January 9, 1996
Project No. 653.080

**SUBJECT: ADDENDUM TO WORKPLAN - GROUNDWATER STUDY
FORMER UNDERGROUND STORAGE TANK**
Memorial Park, 1325 Portland Avenue, Albany, California

REFERENCE: Harlan Tait Associates, Preliminary Site Assessment Workplan, Child Care Center, Memorial Park, Portland and Carmel Avenues, Albany, California, dated April 14, 1994.

SITE PLAN AND BORING LOCATION MAP Child Care Center 1325 Portland Avenue Albany, California	Proj. No. 653.08
	Date: 1/9/96 App'd by: <i>DTC</i>
 Consulting Engineers and Geologists	FIGURE 1

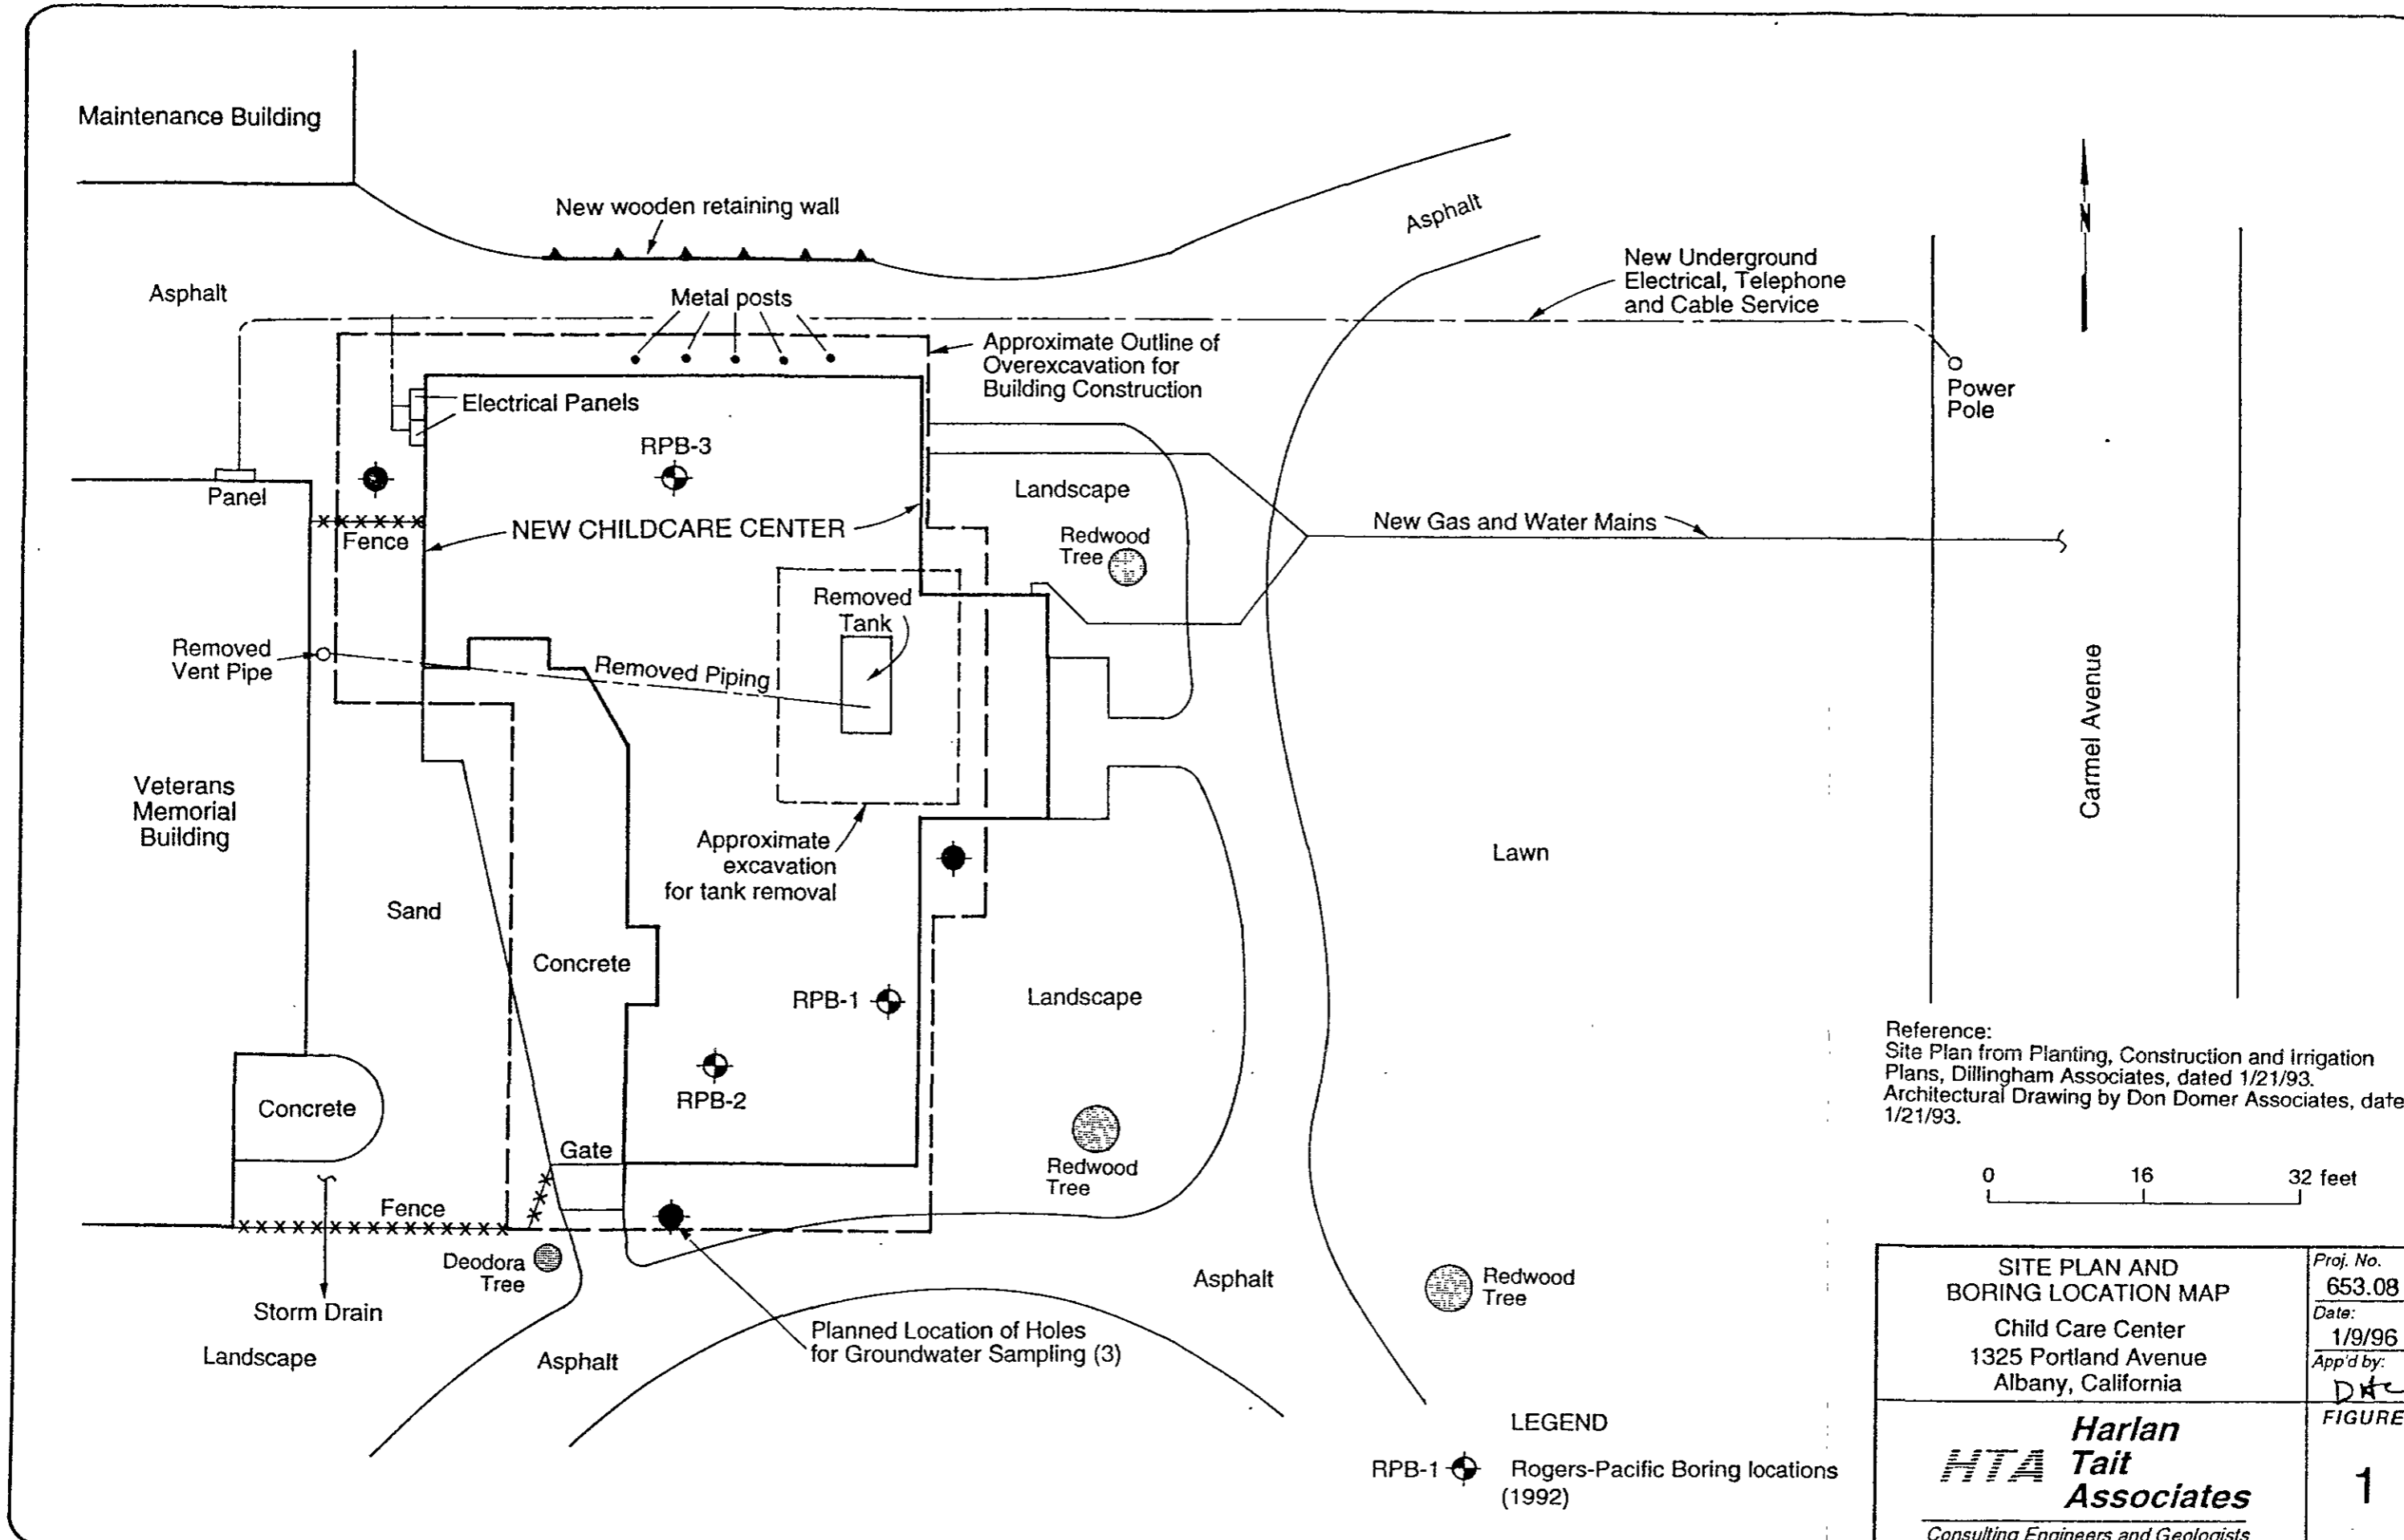
1. One boring location will be revised to the landscape area southeast of the former tank as shown on the attached Figure 1. The planned boring locations west and south of the child care center remain the same.
